Cambridge City Council

SOUTH AREA COMMITTEE

Planning Update Sheet

Comments on Application for Single Storey Rear to 255 Hills Road, Cambridge, Cambridgeshire CB2 8RP - Application Number 10/0996/FUL

The photographs referred to are attached.

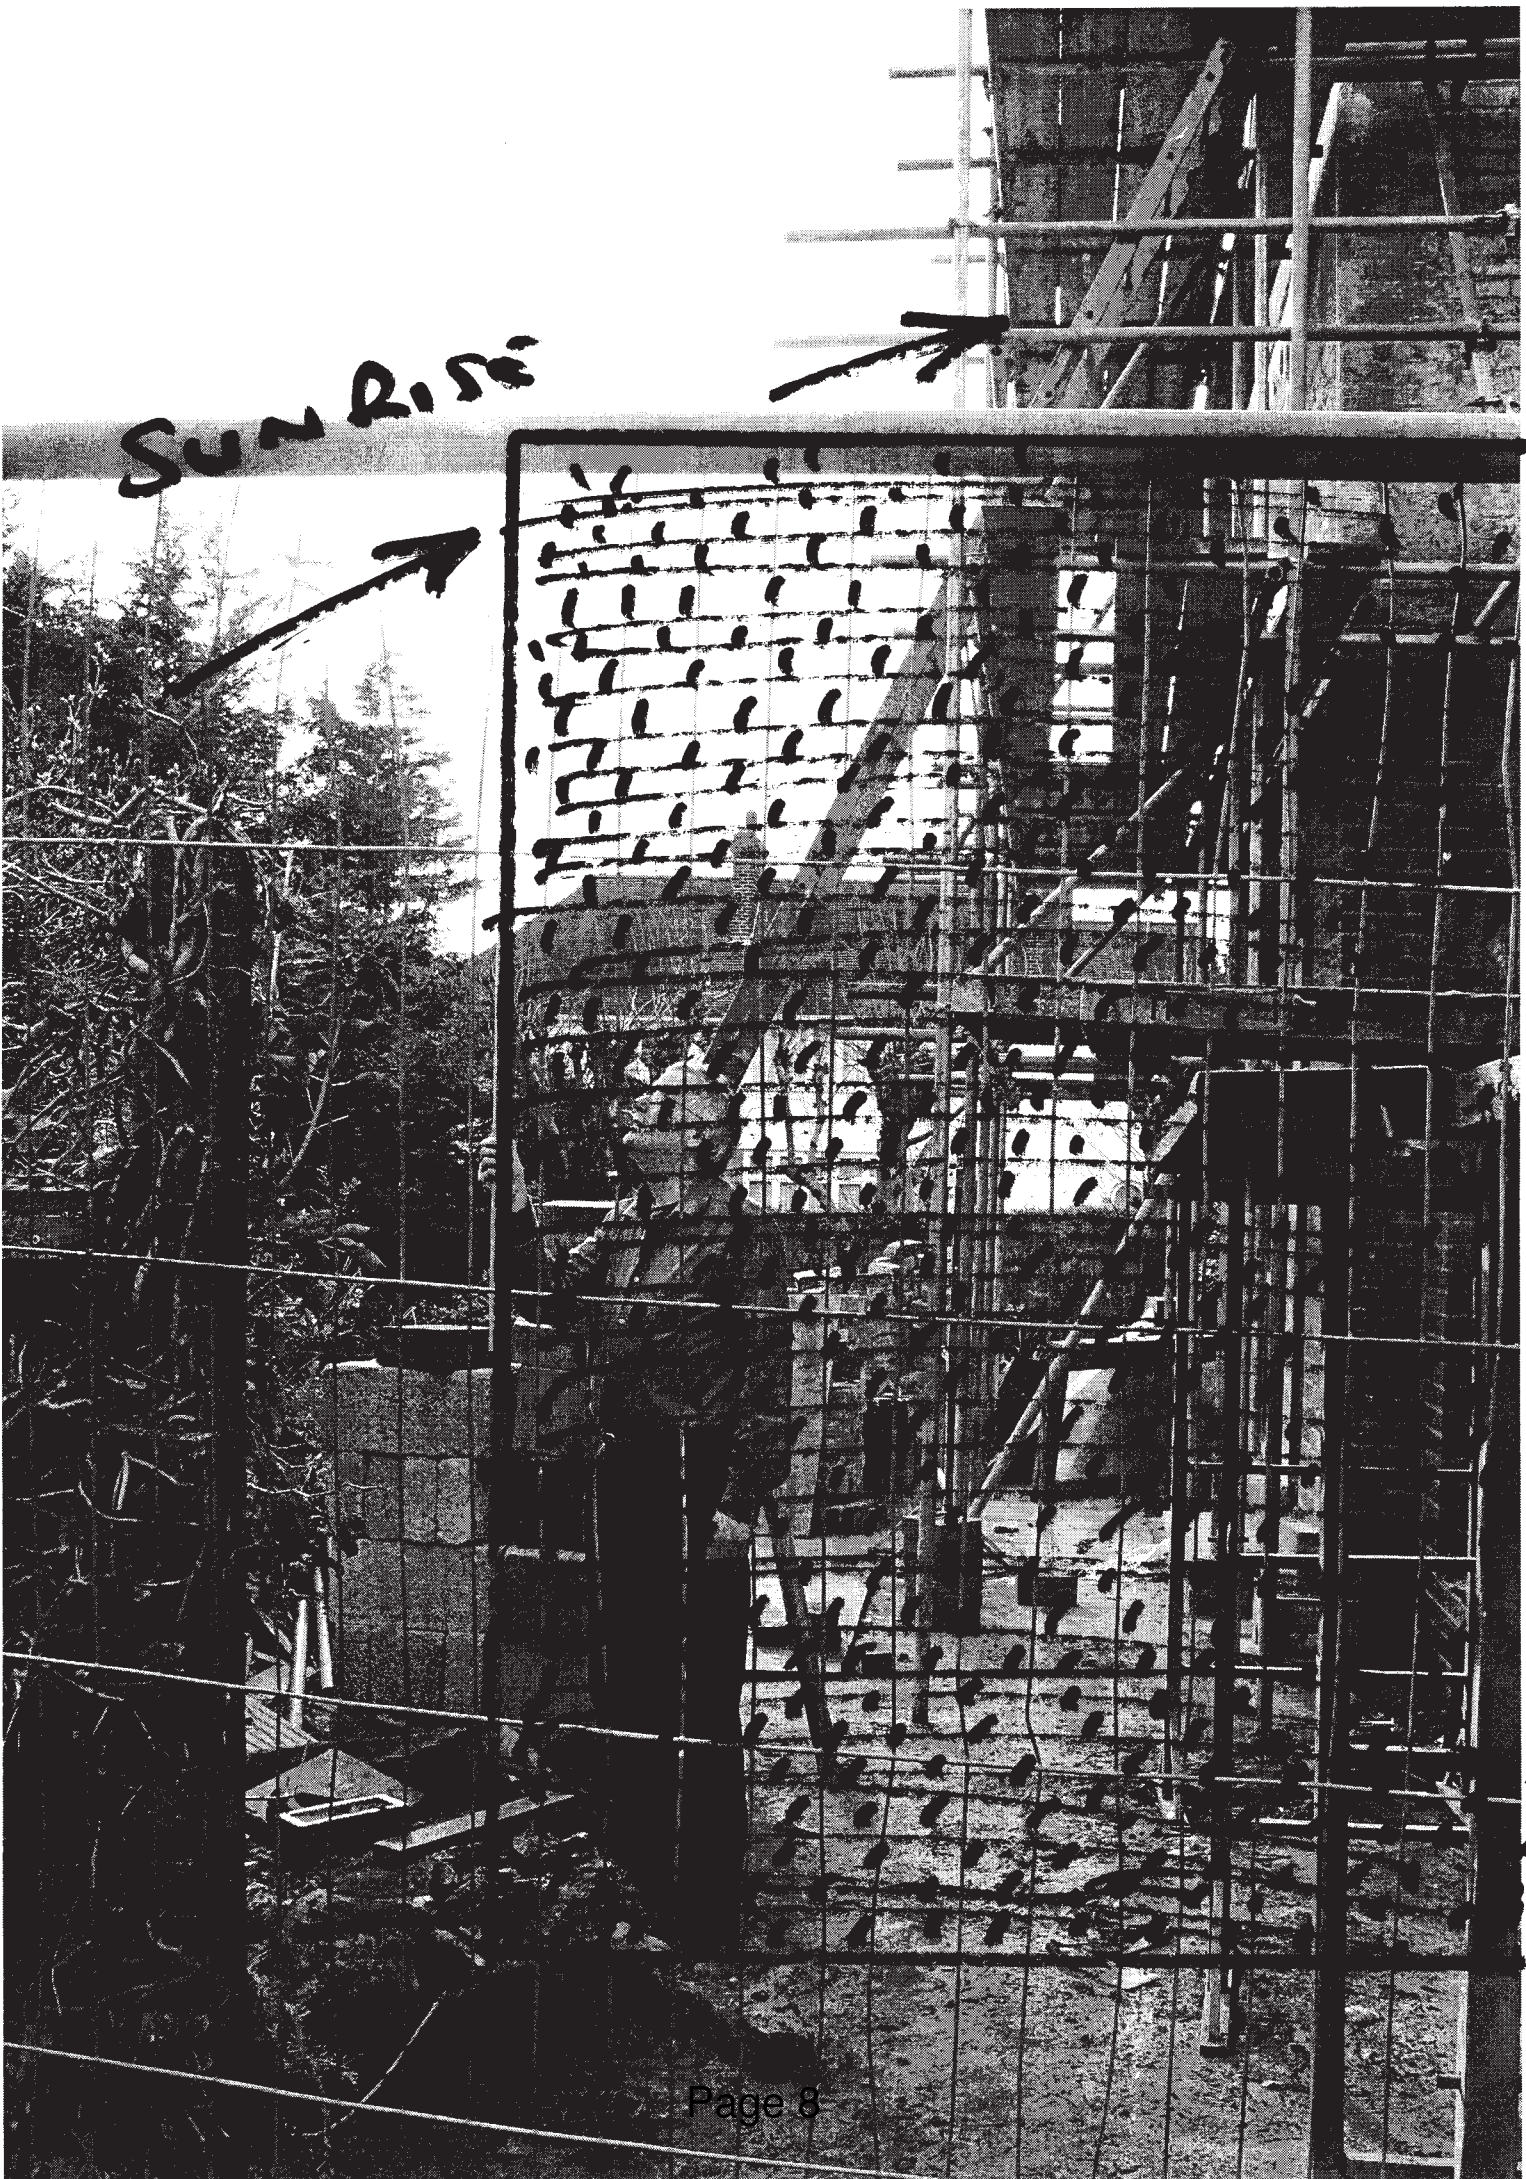
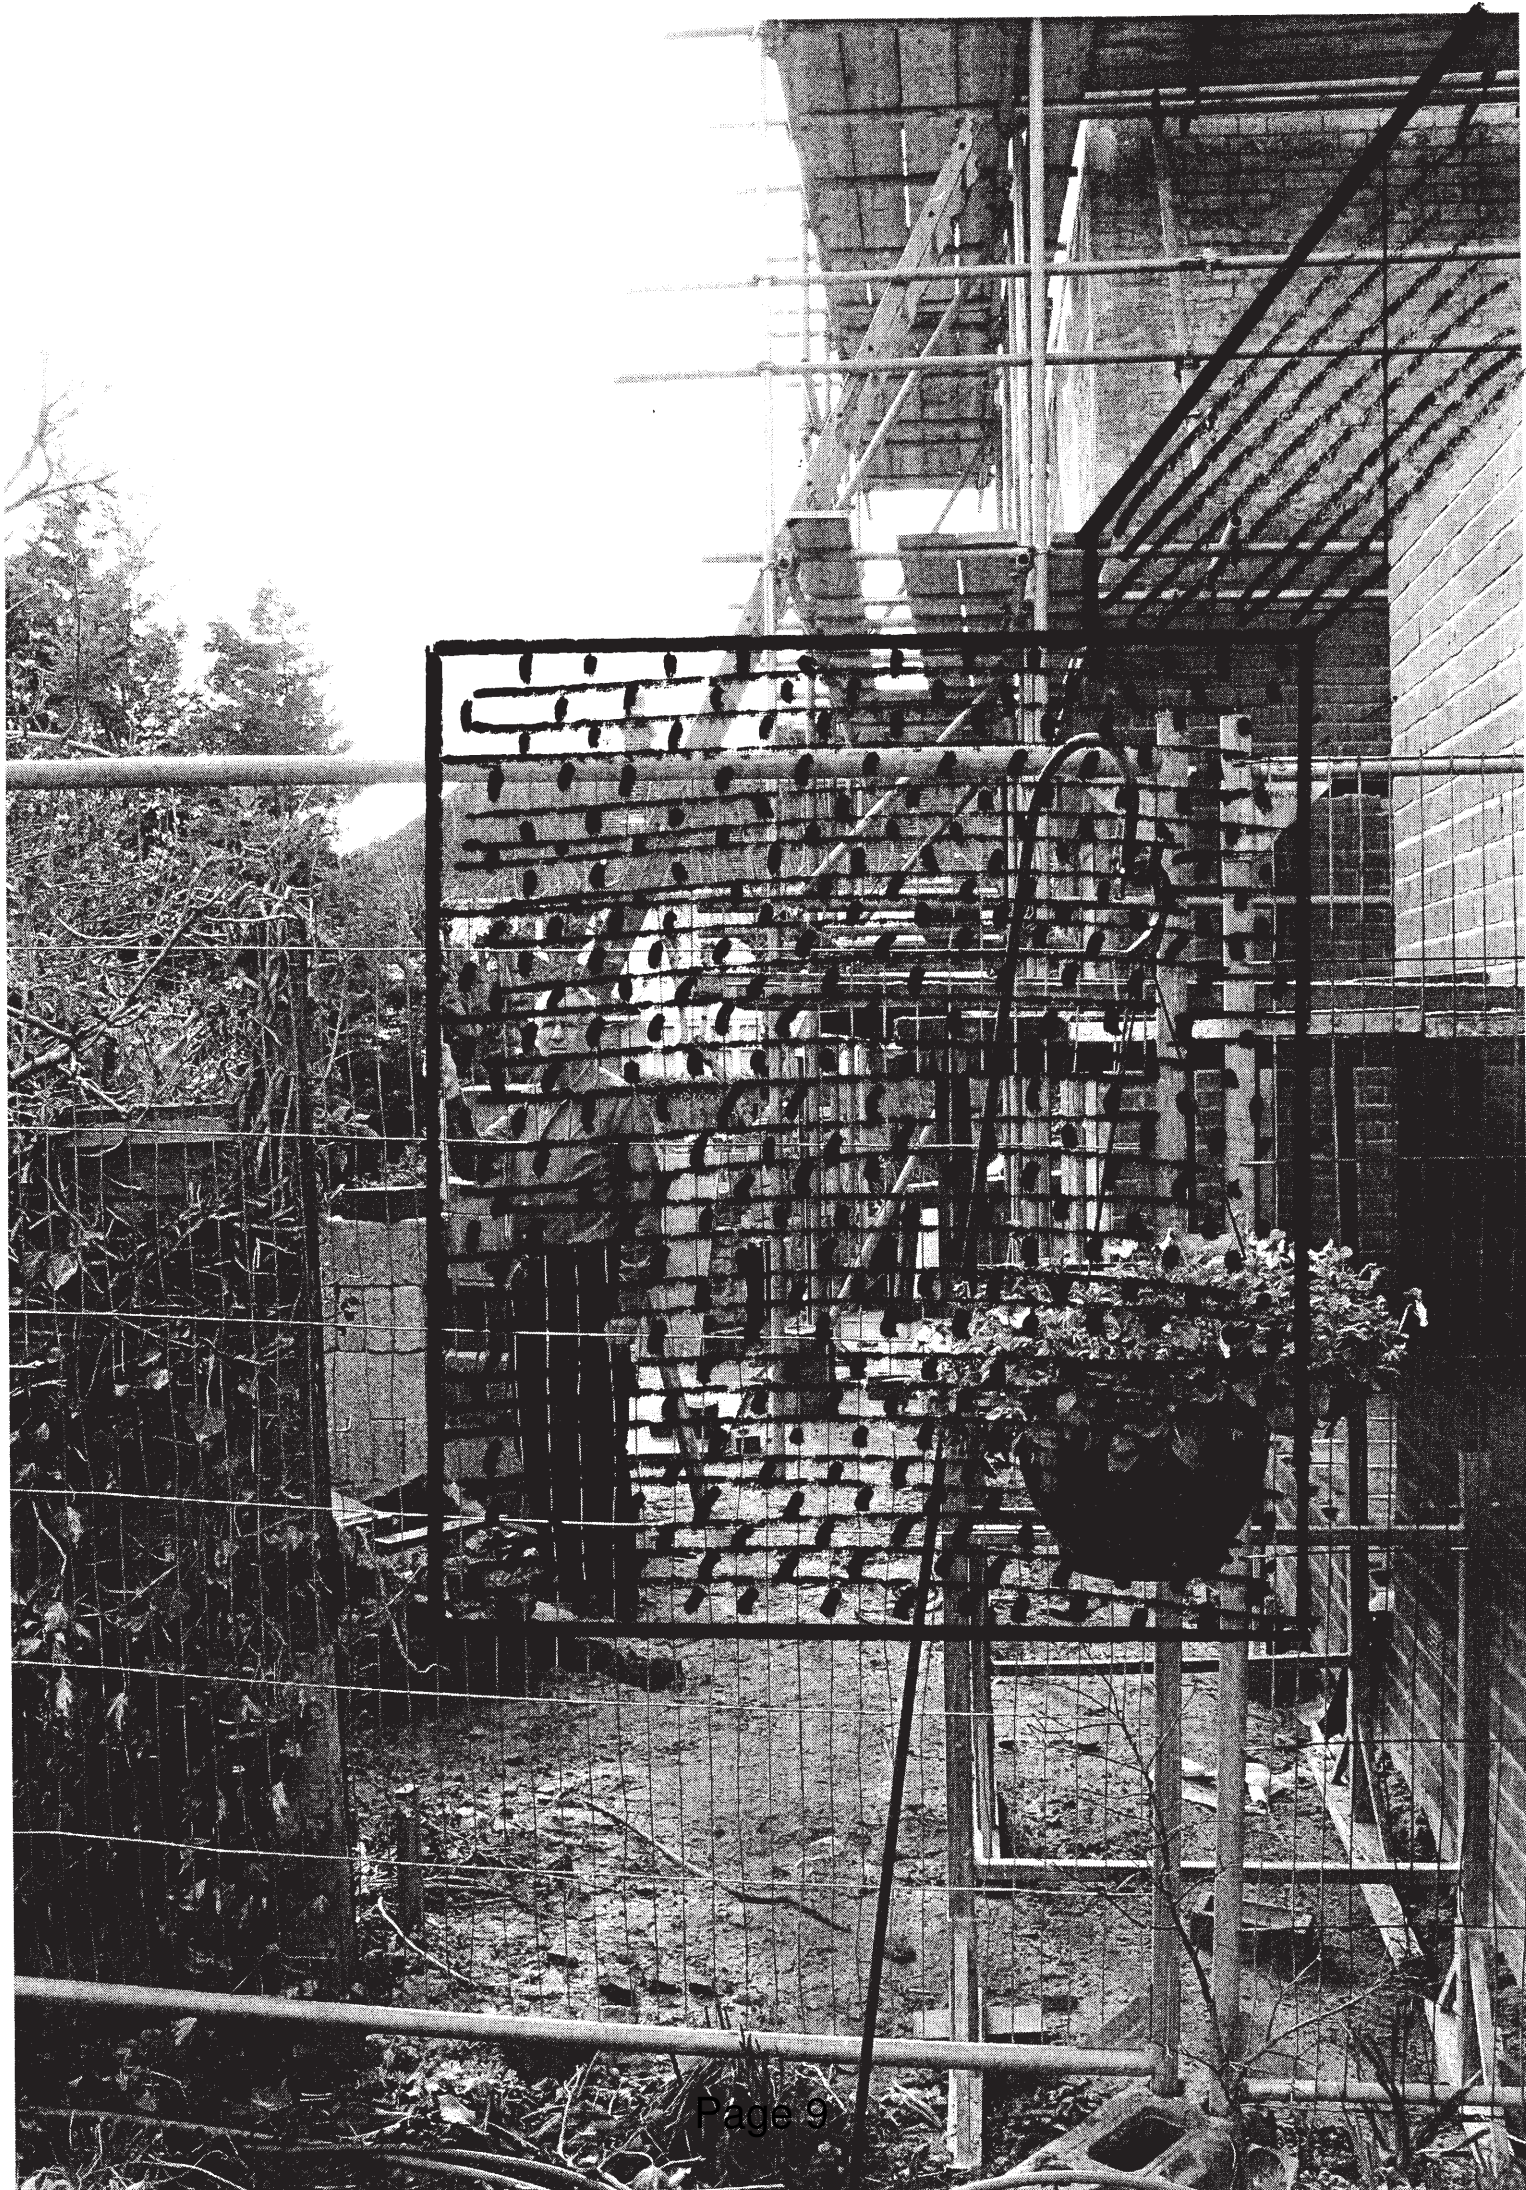
2. In particular, the attached neighbour (myself) lies to the north so that these additions have successively taken the light from the rear of our house. The intended further extension will take the last of this. I attach photographs which show a near-to-completion permitted extension, together with the proposed addition which is the subject of the Application.

The proposed extension is 2.5 metres in depth, 4.8 metres in width and 3.25 metres in height above the neighbours ground level. This height and bulk together with its positioning in proximity to the neighbours property means that it will cause yet more, loss of direct light to its neighbours. The stream of development work that has so far been approved has progressively lead to what now would amount to complete loss of direct light to the rear of the adjacent house.

The highest point (3.25m) of the proposed extension is significantly above the fence line and so will visually impact on its neighbour causing yet more overshadowing and visual domination.

The proposed addition extends a further 2,5 metres back from the rear of the house adding to the 3 metres of the permitted new extension giving a total of 5.5 metres. Besides its combined bulk, this extends the rear line of the property over two metres from the furthest rear wall of the house and so infringes a line that has been respected by all of its neighbours since they were constructed,. This further incursion is therefore out of context with the current house and its neighbours
